**HIGHLAND UNITED NEIGHBORS, INC., COMMENTS ON:**

*(1) DENVERIGHT COMPREHENSIVE PLAN 2040, (2) DENVERIGHT BLUEPRINT DENVER*

*November 28, 2018*

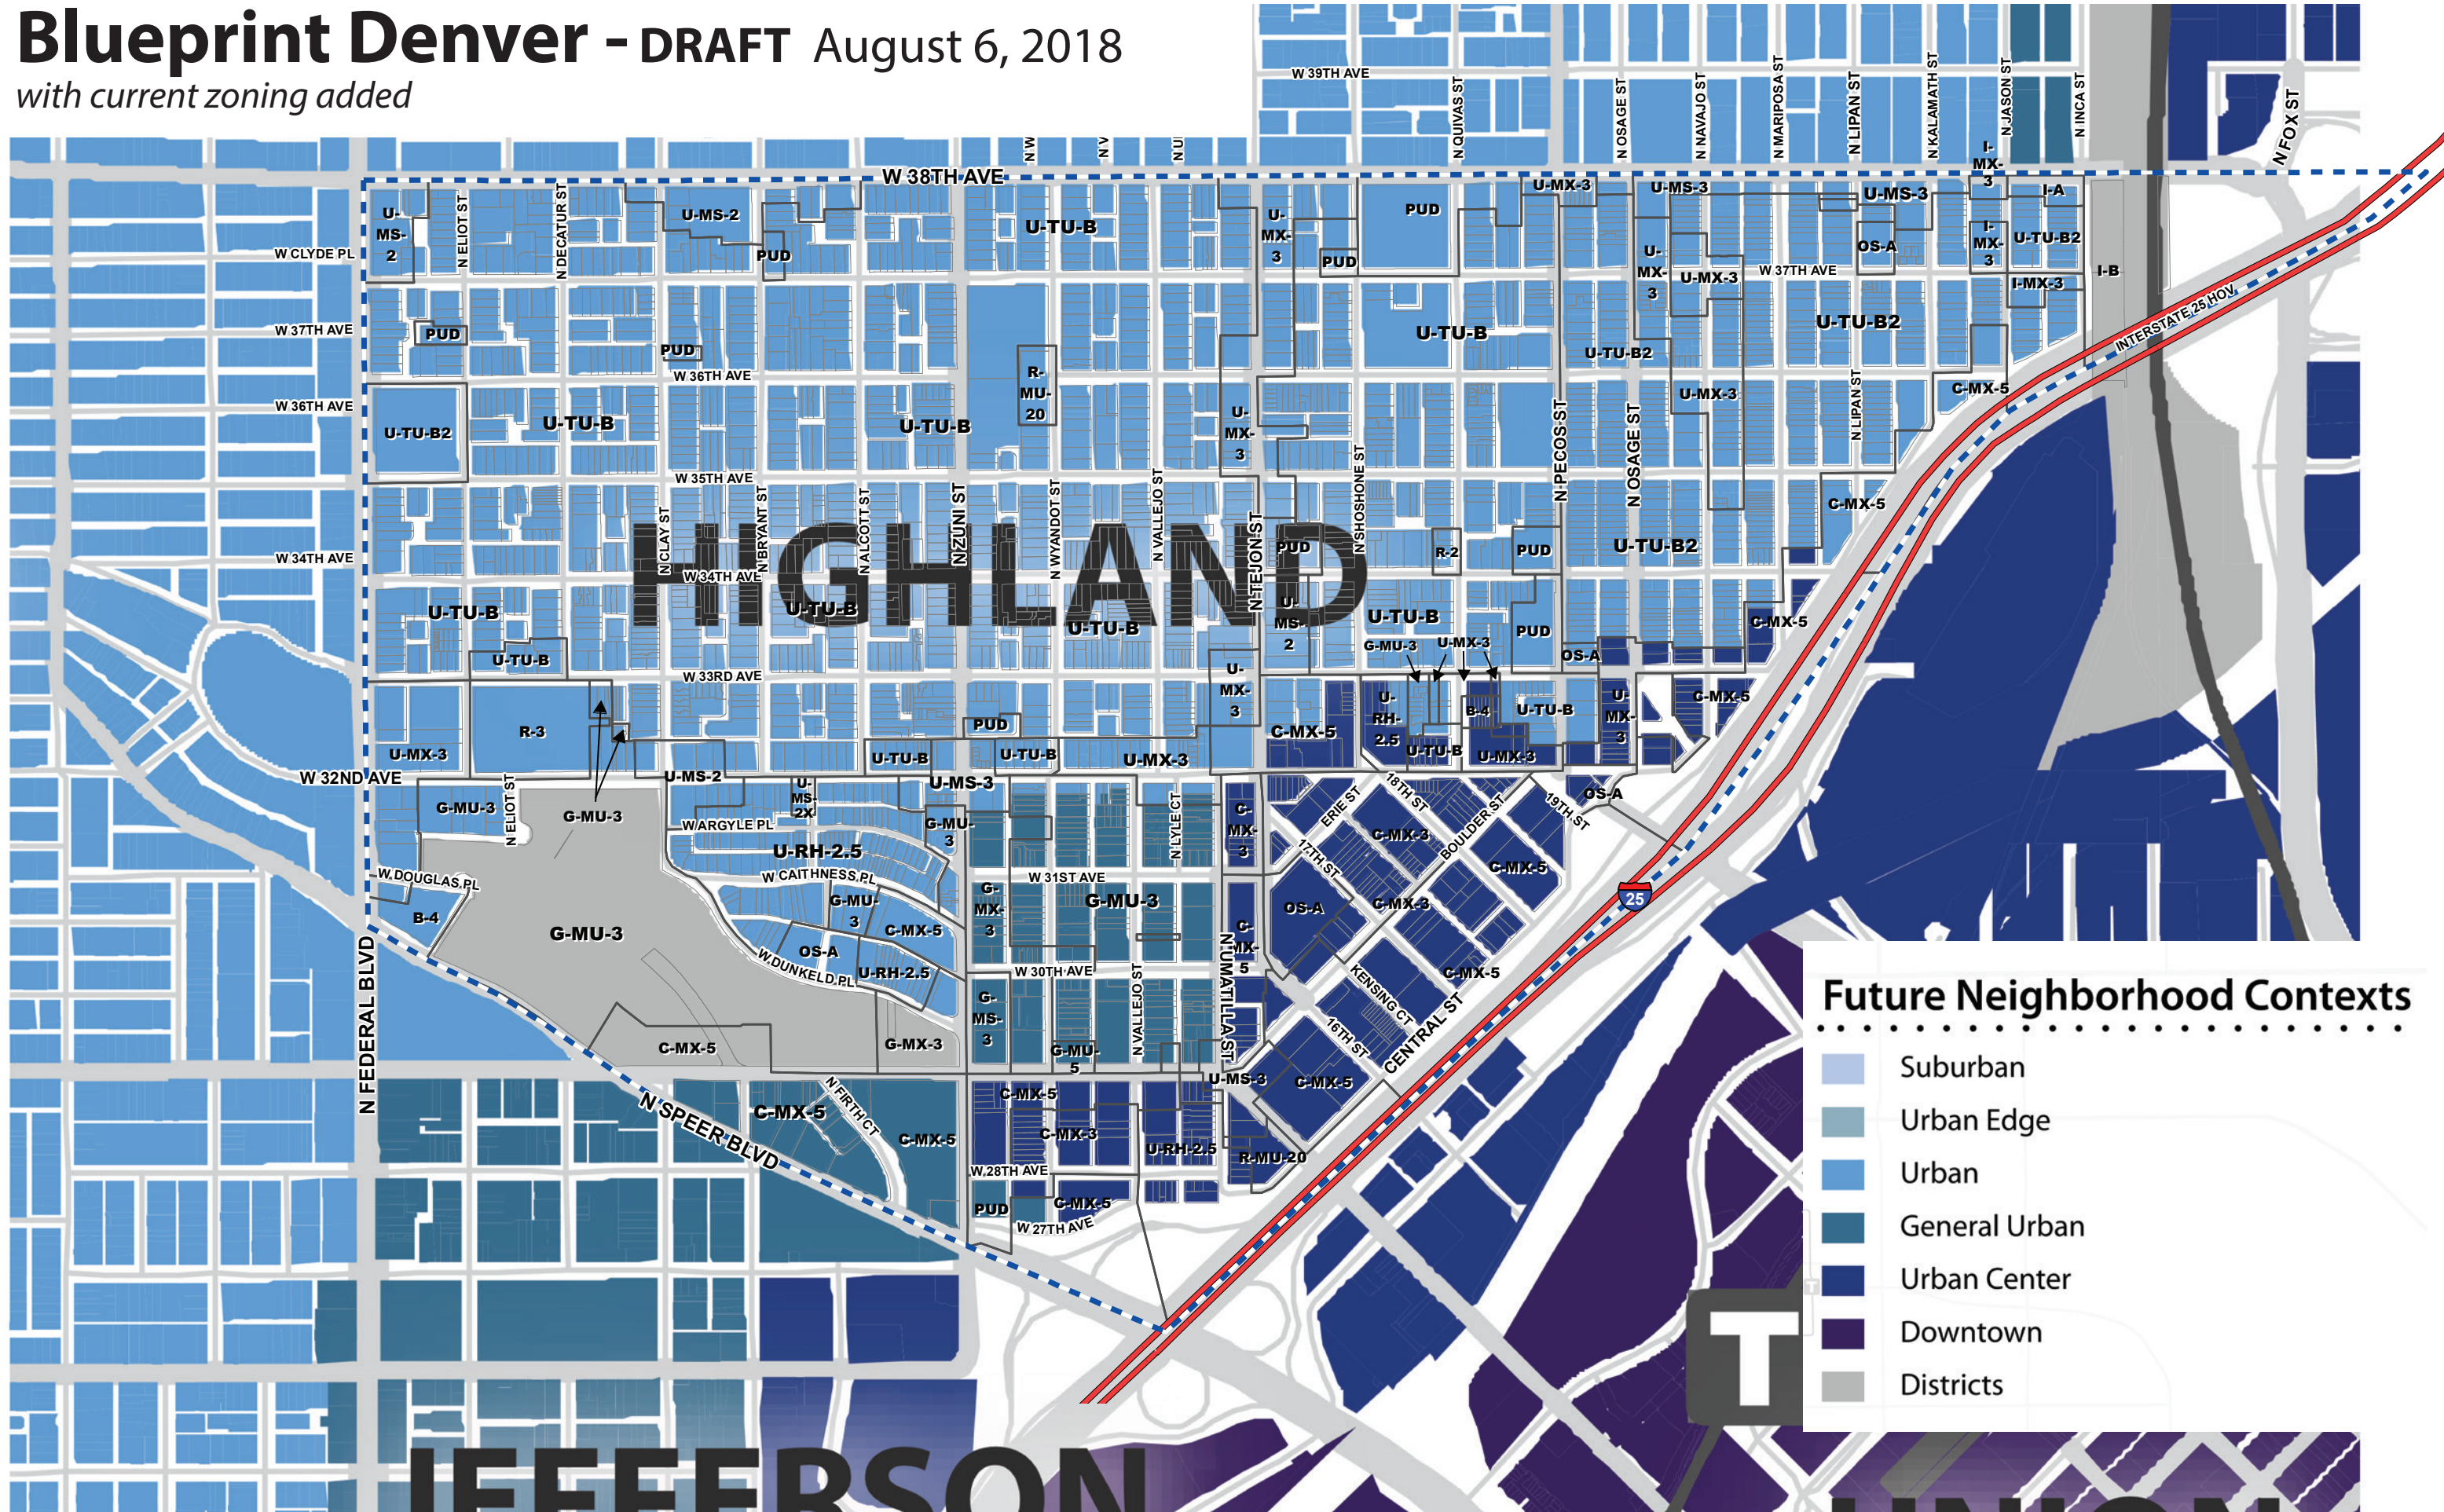
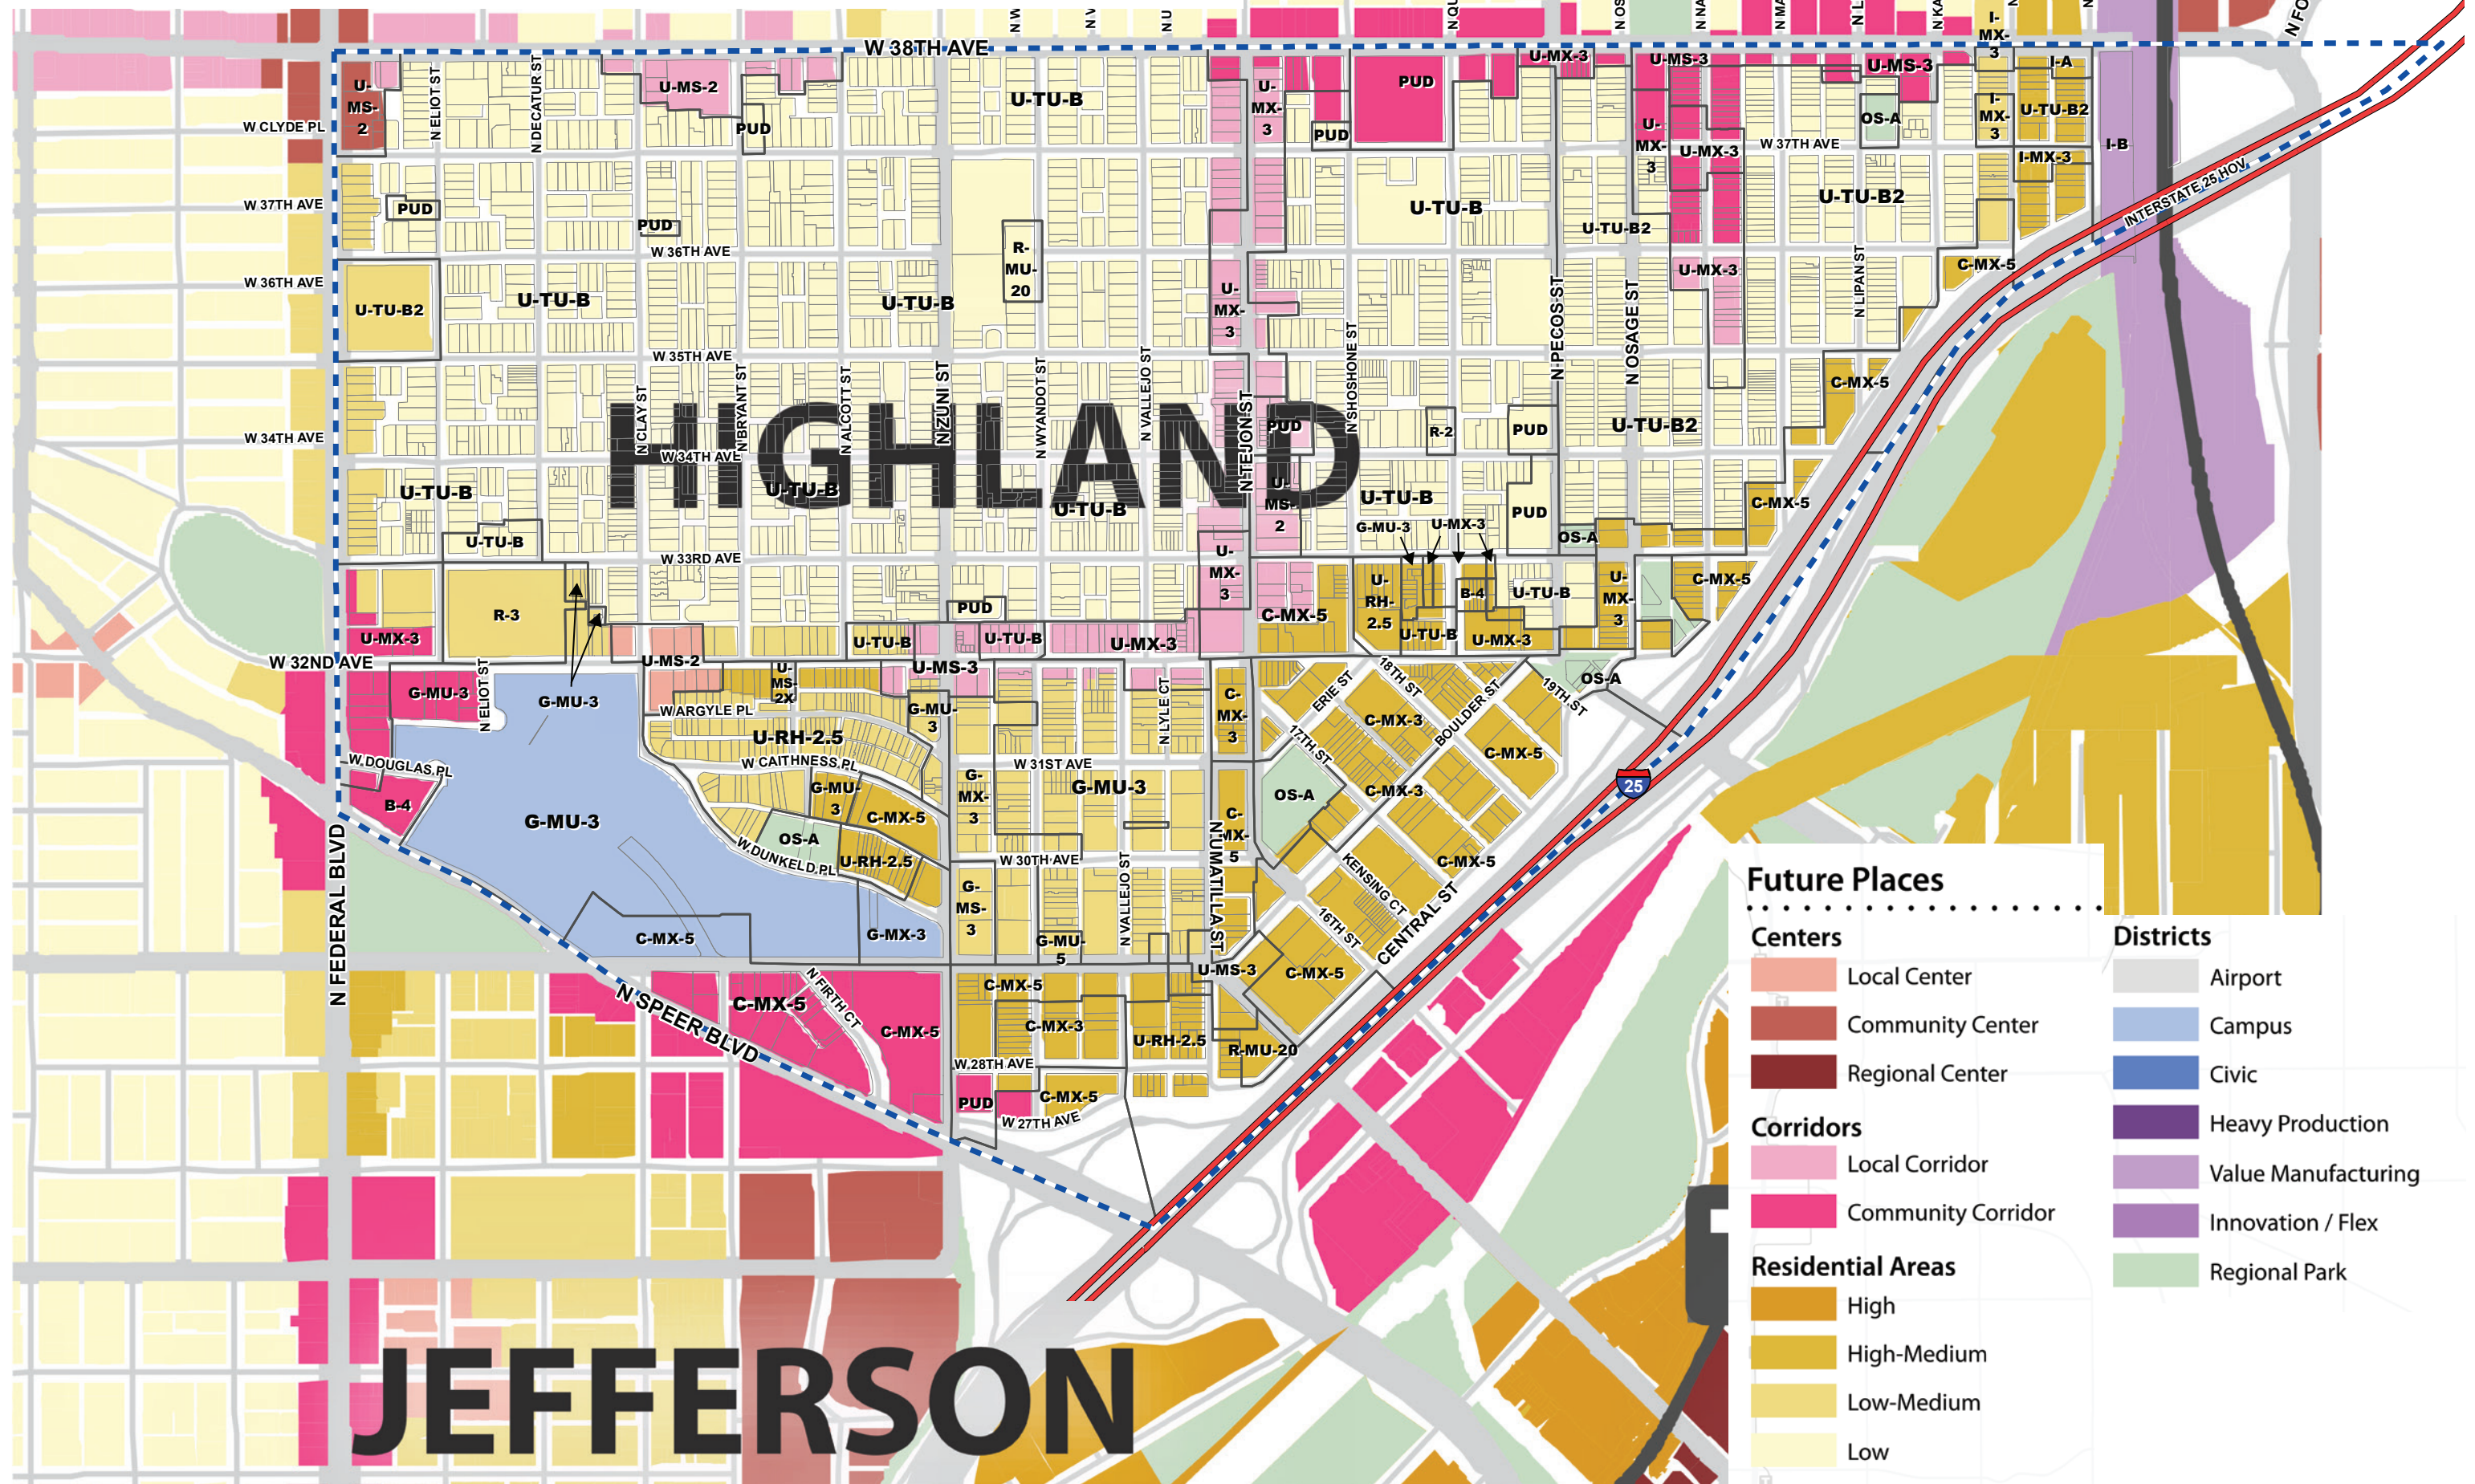
2	<b>FUTURE PLACES MAP</b>	This map mis-characterizes significant portions of the Highland Neighborhood	<i>We request that this map be updated per our version of the map. We have superimposed existing zoning districts to help clarify where the currently proposed map does not correspond to currently allowed zoning, densities, height, and locations of Centers and Corridors. SEE HUNI FUTURE PLACES MAP and specific descriptions of areas requiring modifications that follow:</i>
3	Future Places Map	Some Low Residential areas are noted as Low-Medium and High-Medium Residential Areas	Where Low Residential areas are shown as Low-Medium and Medium-High Residential Areas, the Map and accompanying descriptions of density and height would incentivize redevelopment, destroying the character of those areas of our neighborhood. Specific requests include changing the map where U-TU-B and U-TU-B2 districts along Federal Boulevard (in the Potter Highlands Landmark District) are shown as Low-Medium to Low Residential Areas, changing ALL U-RH-2.5 districts from High-Medium and Low-Medium to Low Residential Areas, and changing other U-TU-B, U-TU-B2 and U-RH-2.5 districts along West 32 <sup>nd</sup> Avenue and in Northeast Highland from High-Medium to Low Residential Areas. SEE HUNI FUTURE PLACES MAP.

4	Future Places Map	Some Low Residential areas are noted as Local Corridors	Where Low Residential areas are shown as Local Corridors, the Map and accompanying descriptions of land uses, density, and height would incentivize redevelopment, destroying the character of those areas of our neighborhood. Our specific request is to change the map where U-TU-B districts along West 32 <sup>nd</sup> Avenue and along Tejon Street are shown as Local Corridors to Low Residential Areas. SEE HUNI FUTURE PLACES MAP.
5	Future Places Map	Some C-MX-3, U-MS-3, U-MX-3, B-4, and G-MU-3 districts are mis-characterized as High-Medium Residential Areas	Where C-MX-3, U-MS-3, U-MX-3, B-4, and G-MU-3 districts are shown as High-Medium Residential Areas, the Map and accompanying descriptions of land uses, density, and height would incentivize redevelopment beyond current zoning regulations, destroying the character of those areas of our neighborhood. These 3-story districts should be shown as Low-Medium Residential Areas. Our specific requests include changing the map where C-MX-3 and U-MS-3 districts south of West 32 <sup>nd</sup> Avenue and east of Zuni Street are shown as High-Medium Residential to Low-Medium Residential Areas, where U-MX-3, G-MU-3, and B-4 districts along West 32 <sup>nd</sup> Avenue, West 33 <sup>rd</sup> Avenue (East of Shoshone) and Pecos Street are shown as High-Medium Residential to Low-Medium Residential Areas, and where a G-MU-3 district at West Caithness Place and Fife Court is shown as High-Medium Residential to a Low-Medium Residential Area. SEE HUNI FUTURE PLACES MAP.

6	Future Places Map	Some U-MX-3 and G-MU-3 districts are mis-characterized as Community Corridors	Where U-MX-3 and G-MU-3 districts are shown as a Community Corridor, the Map and accompanying descriptions of land uses, density, and height would incentivize redevelopment beyond current zoning regulations, significantly altering the character of those areas of our neighborhood. These 3-story districts should be shown as Low-Medium Residential Areas. Our specific request it to change the map

where U-MX-3 and G-MU-3 districts at West 32 <sup>nd</sup> Avenue and Federal Boulevard are shown as a Community Corridor to Low-Medium Residential Areas. SEE HUNI FUTURE PLACES MAP.
7	Future Places Map	The U-MS-3 parcel at the NE corner of West 32 <sup>nd</sup> Avenue and Zuni Street is mis-characterized as a Local Center.	The U-MS-3 parcel at the NE corner of West 32 <sup>nd</sup> Avenue and Zuni Street is mis-characterized as a Local Center. This is a residential structure developed by a neighborhood organization. Our request is to change the mapping from Local Center to Low-Medium Residential Area. SEE HUNI FUTURE PLACES MAP.
8	Future Places Map	The B-4 parcel at the NE corner of Speer and Federal is mis-characterized as a Community Corridor.	The B-4 parcel at the NE corner of Speer Boulevard and Federal Boulevard is mis-characterized as a Community Corridor. Because commercial uses along both Boulevards in Highland tend to be nodal rather linear, we request that this parcel be changed from Community Corridor to Community Center. SEE HUNI FUTURE PLACES MAP.

9	Future Places Map	The C-MX-5 triangle bounded by West 29 <sup>th</sup> Avenue, North Speer Boulevard, and Zuni Street does not fit within the descriptions allowed in a Community Corridor in the Urban Context.	The C-MX-5 triangle bounded by West 29 <sup>th</sup> Avenue, North Speer Boulevard, and Zuni Street should allow 5-story redevelopment (currently allowed for this zoning). Local Corridor designation recommends development up to 3 stories. Community Corridor designation recommends development between 5 and 12 stories in the Urban Context. There is a missing option for areas where 3 to 5 stories is appropriate. Our request is to develop middle option for Corridors where 3-5 stories are recommended. SEE HUNI FUTURE PLACES MAP.
10	Future Places Map	Some U-MS-2 districts are mis-characterized as Community Centers or Local Corridors.	Along West 38 <sup>th</sup> Avenue between Federal Boulevard and Alcott Street, areas zoned U-MS-2 are mapped as Community Center (3-5 stories) or Local Corridor (3 stories). This is another location where the commercial uses are at nodes rather than being continuous along a corridor. These designations on the Map and in accompanying descriptions of land uses, density, and height would incentivize redevelopment beyond current zoning regulations, significantly altering the character of those areas of our neighborhood which are particularly sensitive to change because of the adjoining Potter Highlands Landmark District. Heights are currently limited to two stories. Our request is to change the Map from Community Center and Local Corridor to Local Center to better align with the Highland Neighborhood. SEE HUNI FUTURE PLACES MAP.

11	Future Places Map	Some U-MX-3 and U-MS-2 areas are mis-characterized as Local Corridors, Community Corridors, and Low Residential Areas.	U-MX-3 and U-MS-2 districts along Tejon Street, Osage Street, Pecos Street, and West 38 <sup>th</sup> Avenue are mapped primarily as Local and Community Corridors (5-8 stories). For accuracy, we believe that several changes are needed to more accurately represent the type of development that should occur along these streets: Along Tejon, areas that are primarily residential should be mapped as Low-Medium Residential Areas, and areas that are mixed-use or commercial should be mapped as Local Centers. Along West 38 <sup>th</sup> Avenue, the areas mapped as Community Corridors should be changed to Local Corridors to align with heights

that are allowed by current zoning. The same changes should be made to mixed-use and commercial areas along Osage and Pecos Streets. Where U-MX-3 zoned areas have residential structures, the Future Places Map should be changed to show Low-Medium Residential Areas. SEE HUNI FUTURE PLACES MAP.
12	Future Places Map	Some I-MX-3 and I-A areas are mis-characterized as Low-Medium and High-Medium Residential Areas.	Along West 38 <sup>th</sup> Avenue, east of Kalamath, the I-MX-3 and I-A areas are mis-characterized as Low-Medium and High-Medium Residential Areas. We request that these areas be changed to Local Corridor for consistency with the rest of the 38 <sup>th</sup> Avenue corridor east of Tejon. SEE HUNI FUTURE PLACES MAP.
13	Future Places Map	The C-MX-5 district on the north side of the intersection of West 32 <sup>nd</sup> Avenue and Tejon Street is characterized as a combination of Local Corridor and Medium-High Residential while being primarily Medium-High Residential.	The C-MX-5 district on the north side of the intersection of West 32 <sup>nd</sup> Avenue and Tejon Street is characterized as a combination of Local Corridor and Medium-High Residential while being primarily Medium-High Residential. We request that the entire C-MX-5 zone district at this location be shown as a Medium-High Residential Area to conform to actual and proposed development. SEE HUNI FUTURE PLACES MAP.
